**ZONING AMENDMENT,  
PLANNED UNIT DEVELOPMENT &  
SUBDIVISION STAFF REPORT**

**Date: April 19, 2007**

Robert Moore Park Subdivision

4213 Halls Mill Road  
(East side of Halls Mill Road, 185'+ North of Alden Drive).

## SUBDIVISION & ZONING DETAIL

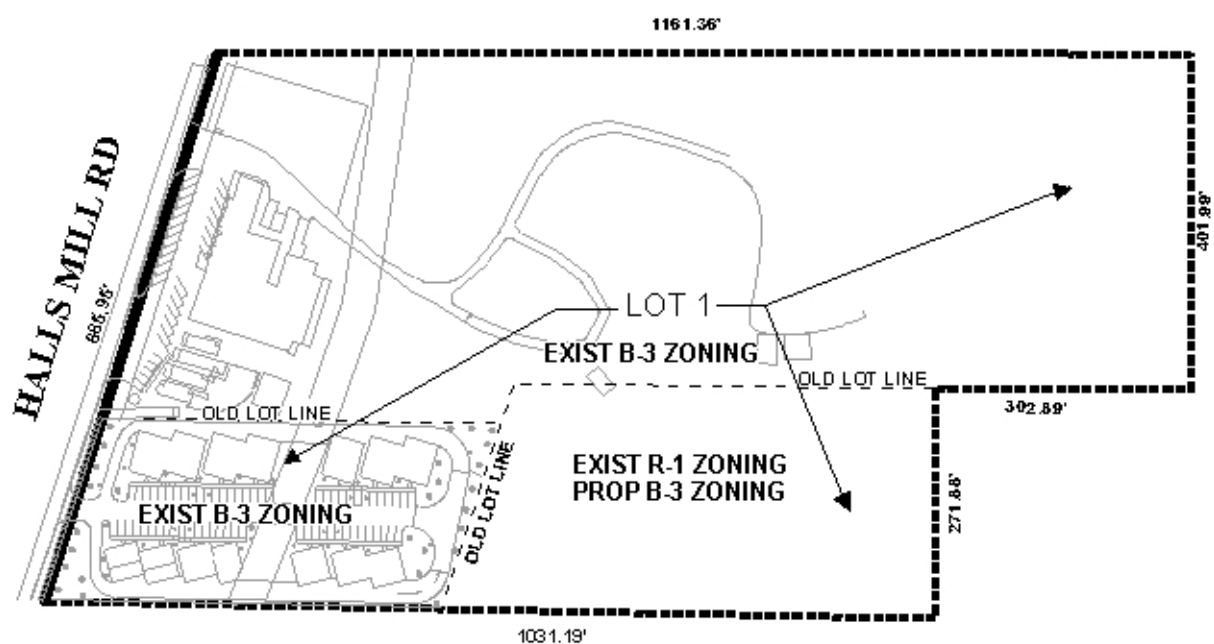
- 1) revision of the plat to depict the minimum building setback line across the entire Halls Mill Road frontage area, with accommodations made for the required dedication of right-of-way.

# SITE PLAN

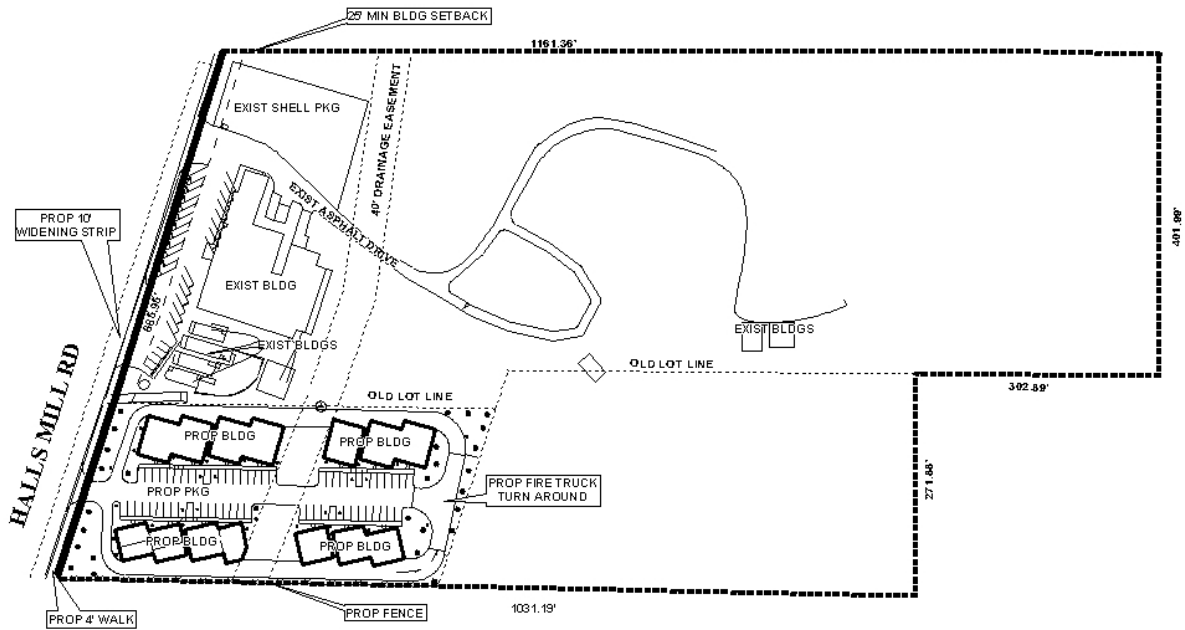
As mentioned in the March 15th staff report, there are a few specific issues that require closer consideration. The first deals with a discrepancy between the uses as listed on the application and the use and parking data as shown on the plan submitted. The application states that the use is to be multiple tenant retail/office, however, information in the parking data calculations on the site plan indicate office and warehouse uses.

Based upon information on the site plan, the proposed new development will contain 14 office spaces containing 920 square feet each, located in eight separate buildings. Each building ranges in size from 1,600 to 4,000 square feet. The Parking Data table on the site plan then lists that there will be 13 "warehouse" units. Calculations by staff show that the proposed new

development will have a total building area of 24,890 square feet, and that 12,880 square feet of that will be dedicated to office uses. The remaining 12,010 square feet will be for “warehouse” space. It has been the policy of staff to consider “warehouse” areas less than the space allocated for office uses to be “storage” rather than true “warehouse” space, thus the storage area should have a parking ratio of 1 space per 300 square feet, rather than the warehouse ratio of 1 space per warehouse employee. Therefore, either the application should be revised to provide the necessary parking, or the application should be revised to change the office and warehouse area ratios to ensure that the warehouse areas total more than 50% of the building area.

Also it should be pointed out that Planned Unit Development approval is site plan specific. The site plan does not depict any stormwater detention on site, yet such detention will likely be required. If the provision of detention will result in an altered site plan, the site plan must be brought through the PUD approval process – if the current site plan is approved by the Planning Commission. However, the applicant may revise the site plan prior to approval of the PUD to provide for a detention area, so that reapplication may not be required just to accommodate a detention area.

- 1) revision of the site plan to accommodate a parking ratio of 1 space per 300 square of new construction, or revision of the building programming to increase the ratio of “warehouse” area to “office” area;

- 2) revision of the site plan to comply with Engineering comments (The storm water ordinance does not allow water to be concentrated onto an adjacent property without a hold harmless agreement. All storm water must tie to the City of Mobile storm drainage system. Show general detention location on PUD site plan application. Provide 100-year detention on site. Discharge from the detention pond will have to be conveyed to the earthen channel north of the existing storm drain running through the property north of proposed subdivision. Must comply with all storm water and flood control ordinances. Any work performed in the right of way will require a right of way permit.); and

- 3) revision of the site plan to depict the 25-foot minimum building setback line from the right-of-way dedication area for the portion of the site that will accommodate new construction.
